Isolation Proposals, Revised 2025-03-12

Submitted by Jason Potterf - Cisco

Topic: Annex J Expansion

Revise Annex J as shown

Figure J-1 Isolated MPoE System Diagram

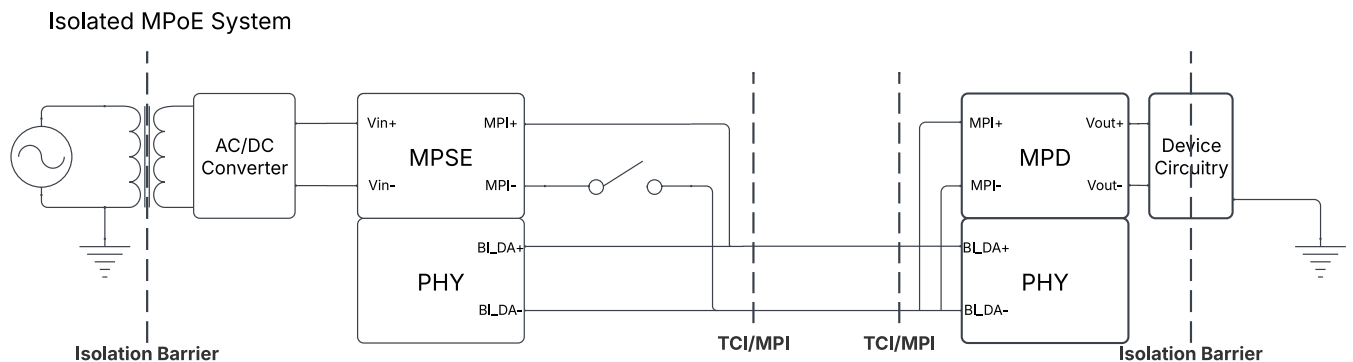
Isolated MPoE systems, as shown in Figure J-1, are recommended for mixing segments that crosses any of the following:

- Ground references
- Boundaries between separate power distribution systems
- Boundaries of a single building

Isolated MPoE systems have isolation requirements that are aligned with Clause 33 and Clause 145 isolation requirements. These isolation requirements target compatibility with low-voltage systems that prohibit intentional grounding of any

conductor, such as a Safety Extra-Low Voltage (SELV) system. Because the MPSE outputs are isolated and floating, disconnecting the more negative conductor is sufficient to stop the flow of power and ground loops are not present.

Figure J-2 Grounded MPoE System Diagram

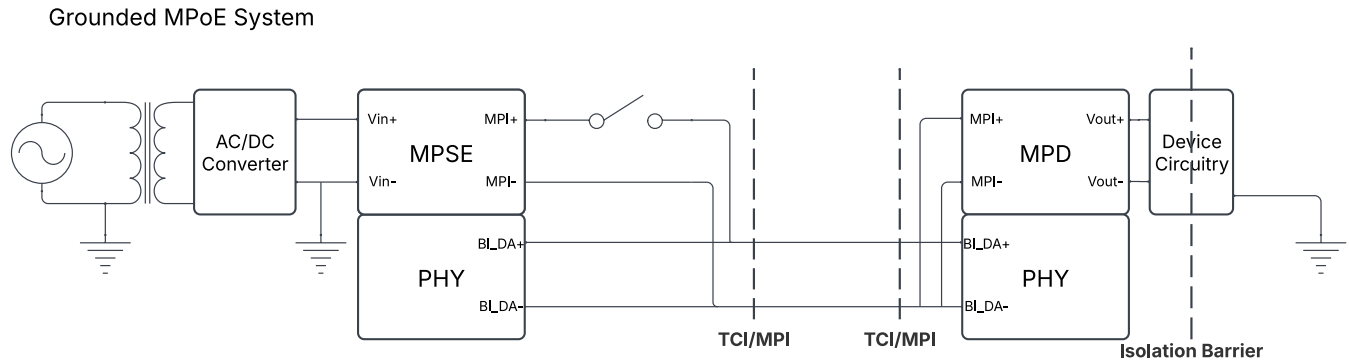
Grounded MPoE systems, as shown in Figure J-2, are recommended for mixing segments which, with all associated interconnected equipment, share a common, continuous ground.

Grounded MPoE systems have isolation requirements that are aligned with Clause 104 isolation requirements. These isolation requirements target compatibility with low-voltage systems that intentionally ground one conductor, such as a Protective Extra-Low Voltage (PELV) system. Grounded MPSEs are permitted to ground the more negative conductor of their power supply, but must switch their more positive conductor to ensure that a ground path does not circumvent the MPSE's ability to stop the flow of power. MPDs are required to meet a lower isolation requirement to ensure the current supplied by the MPSE on the MPI returns to the MPSE via the MPI.
